Product / Process Change Notification (PCN)

PCN #: PCN_WIRL-BTLE_WIRL-EVAL_20221230

Affected Series: WE-WIRL-BLE; 261101024000
 WE-WIRL-EVAL; 2611019024001,
 2611069024001, 261114902401

Existing production line

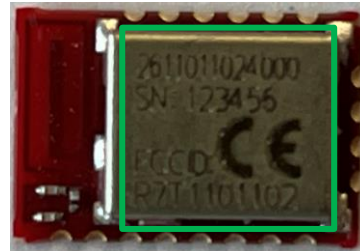
1. Neither electrical nor mechanical properties of the part will change.
2. The modules of the additional production line will no longer have a label. Instead, they will be marked using laser technology.
3. Process and machine approval is according to internal requirements released by the Product Management Department.
4. Affected part numbers are 2611011024000 (Proteus-III module), 2611019024001 (Proteus-III evaluation kit), 2611069024001 (Proteus-III mini evaluation board) and 261114902401 (Proteus-III family board).

The production line, at which the module was produced, can be traced by the lot number.
